**WINSLOW-LINDBERGH REGIONAL
AIRPORT
Winslow, Arizona**

AIRPORT MASTER PLAN - 1998
APPENDIX C - MISCELLANEOUS CORRESPONDENCE

Winslow-Lindbergh Regional Airport
Airport Layout Plan Review

REVIEW COMMENTS - WINSLOW-LINDGERGH REGIONAL AIRPORT LAYOUT PLAN

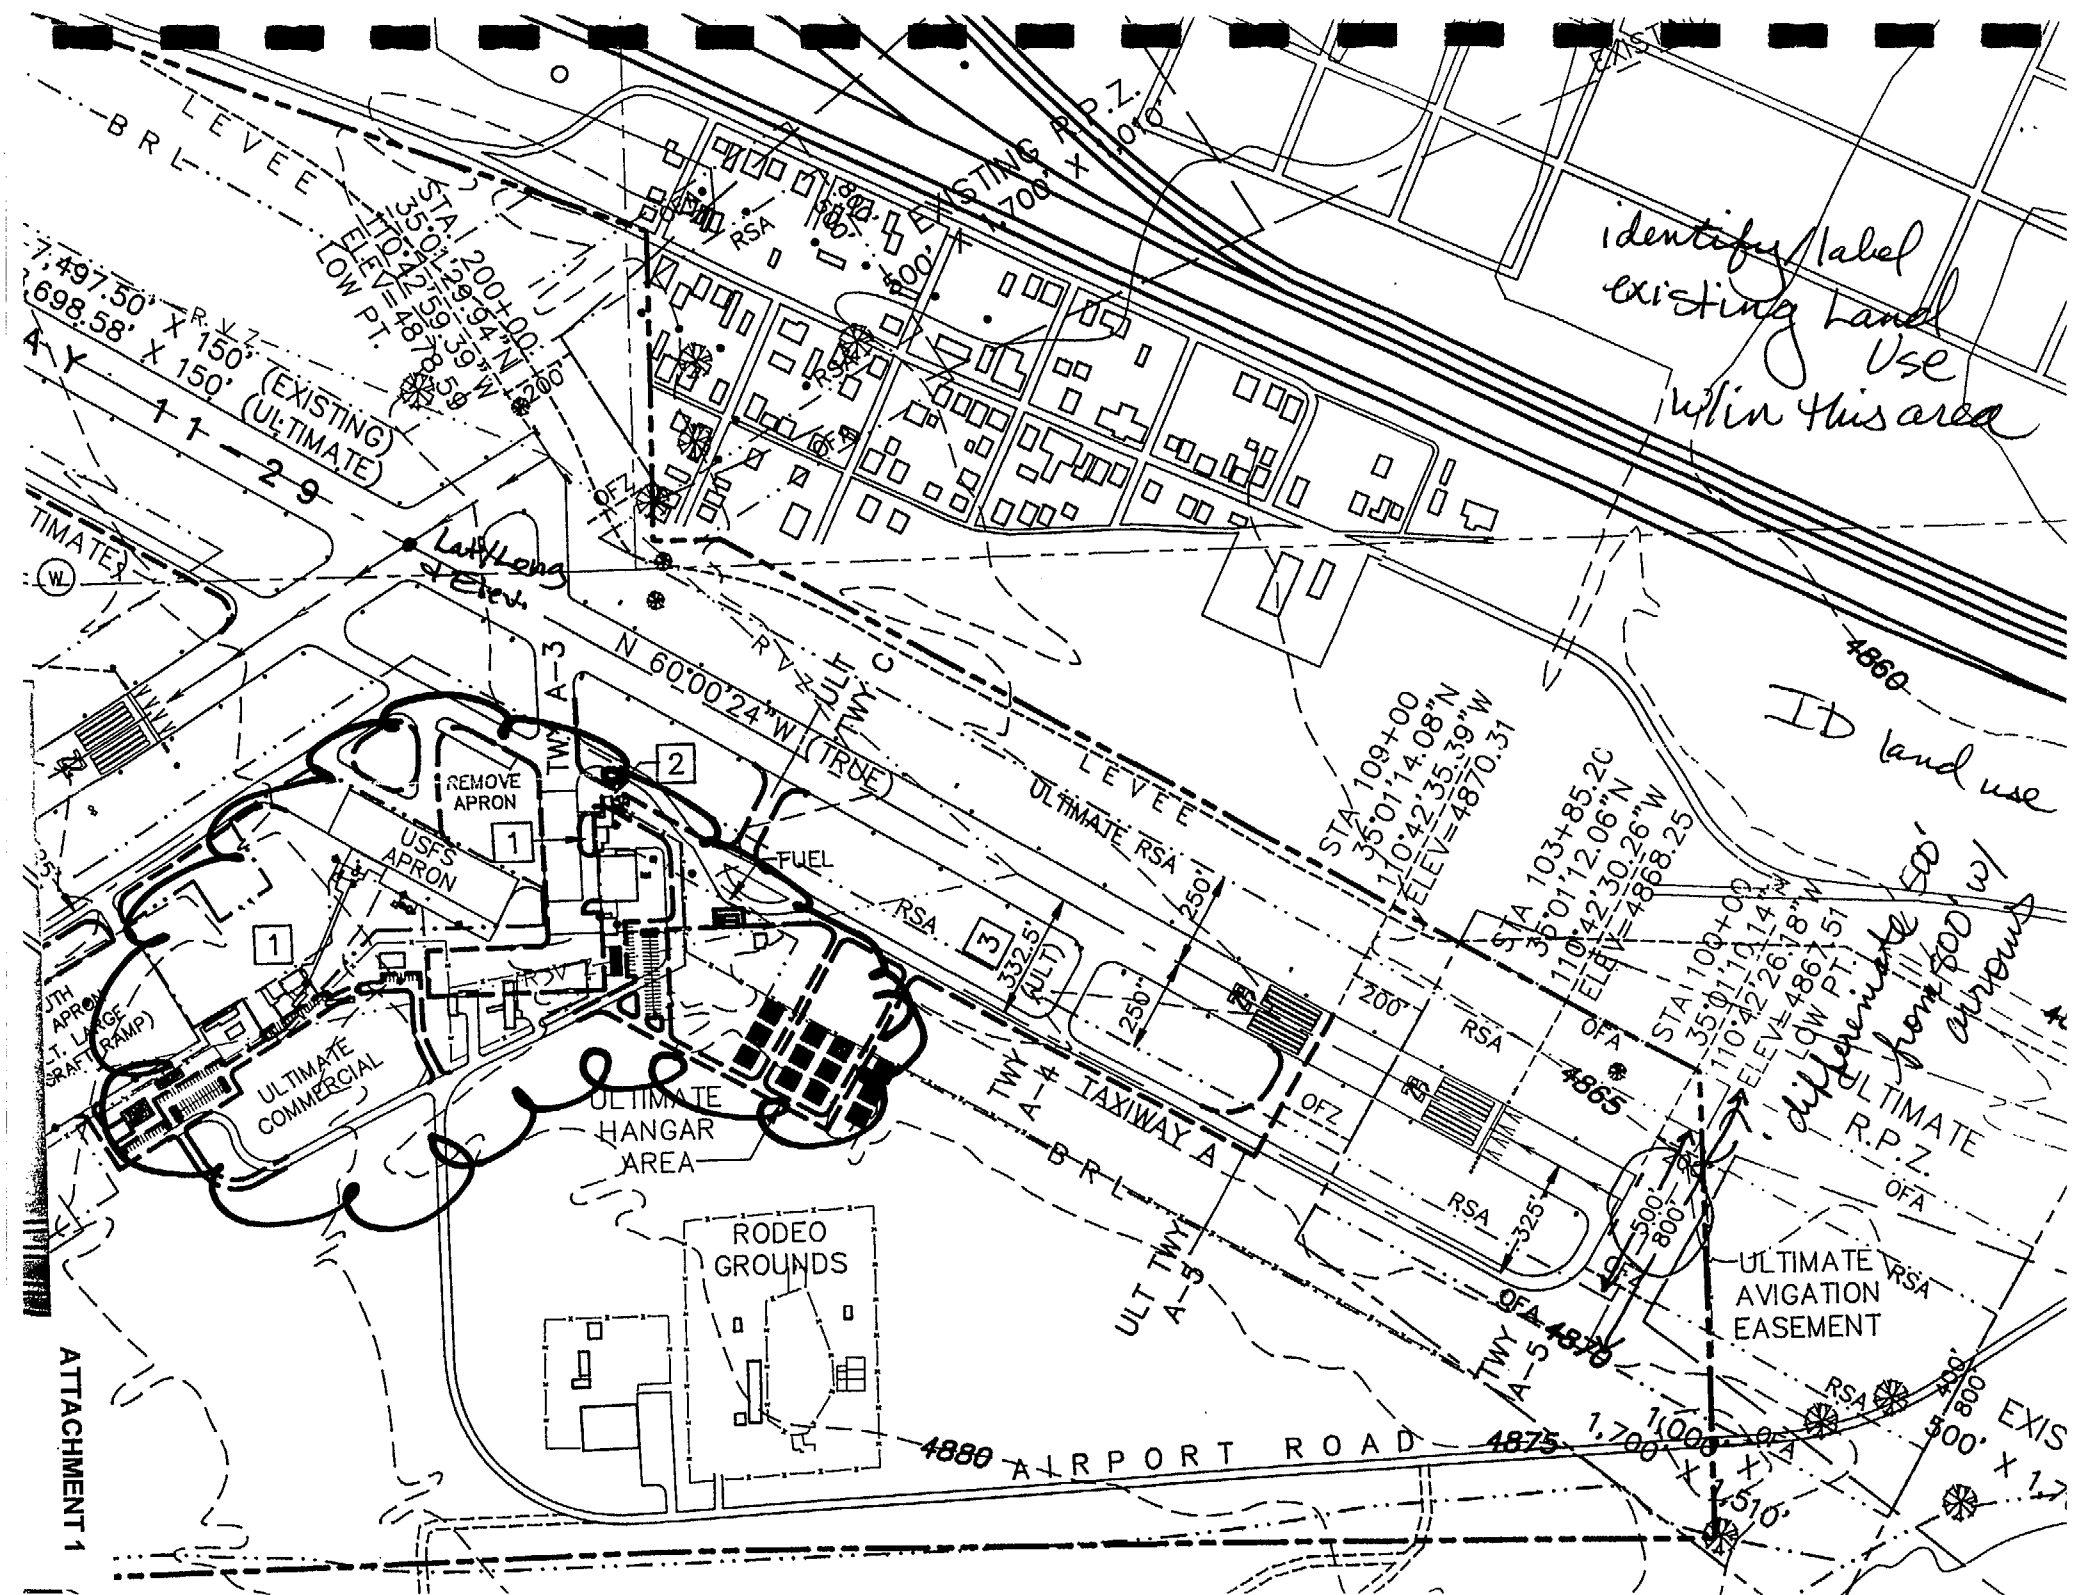
5. NAD 83 identifier: It is mandatory that the ALP drawing indicate the use of NAD 83 for all Lat/Long measurements. Add "note" to indicate this.
6. Drawing Lines: The **OFZ, BRL and RVZ lines** are not able to be differentiated from one another on the drawing by their distinct symbolism. Please make each more distinct in appearance from one another. (**See Attachment 1**)

BRL Line: I loose site of where the BRL line is within the terminal area. See circled area on **Attachment 1**. Please darken/highlight so appearance is clarified.

- Future Development: Use of "dashed or screened lines" should be used, not bold. Bold is for existing facilities. Change accordingly. Use numbers next to facilities and develop a "facilities list". There are no indicators of what facilities exist within area circled on **Attachment 1**. Clarify for any other facilities as well on airport not currently labeled.

Figure 3-2. Obstacle free zone (OFZ) for visual runways and runways with not lower than 3/4-statute mile (1 200 m) approach visibility minimums

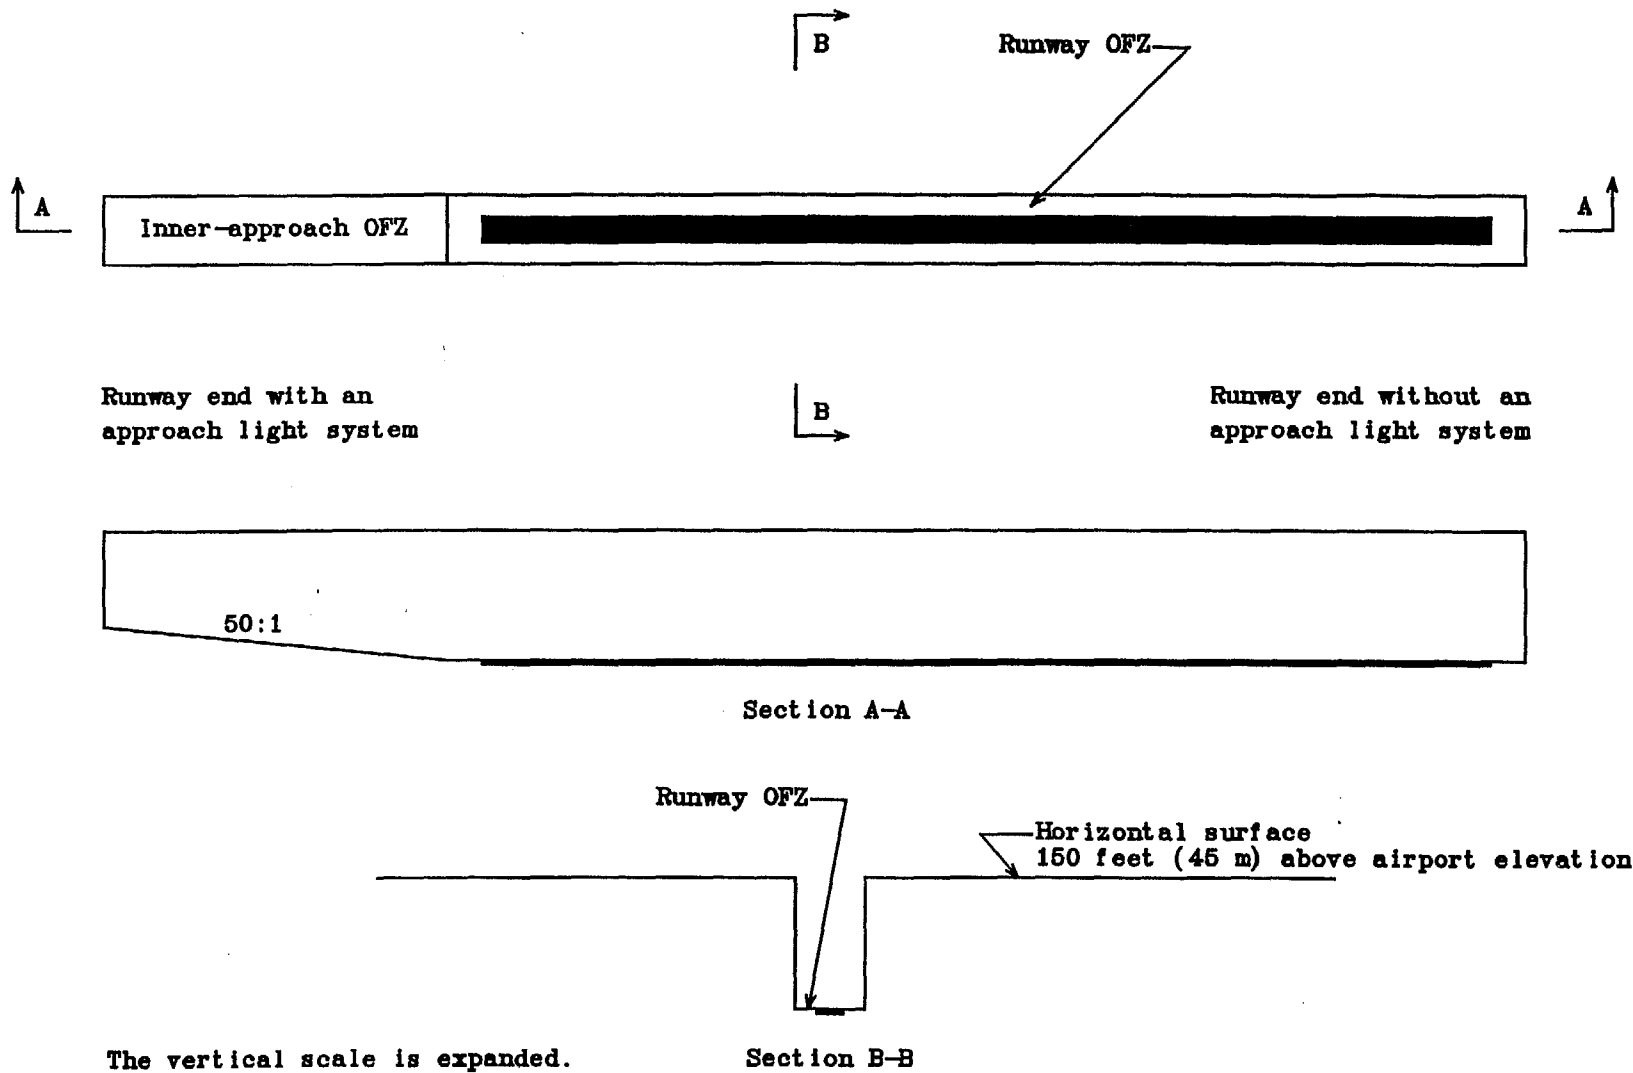
10. Obstacle Free Zone line needs to be shown the entire length of runway. See Attachment 2. Make correction accordingly.
11. Taxiway width: Add to drawing the width of taxiway "A-3".

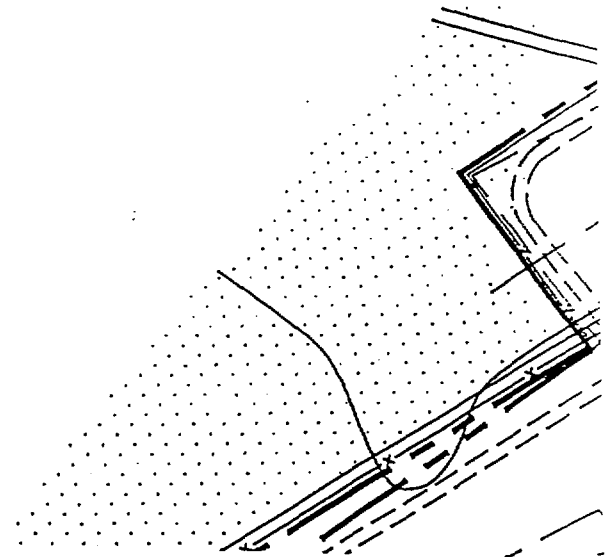
15. Facilities List: Add a "facilities list" onto drawing. See Attachment 3 (example).
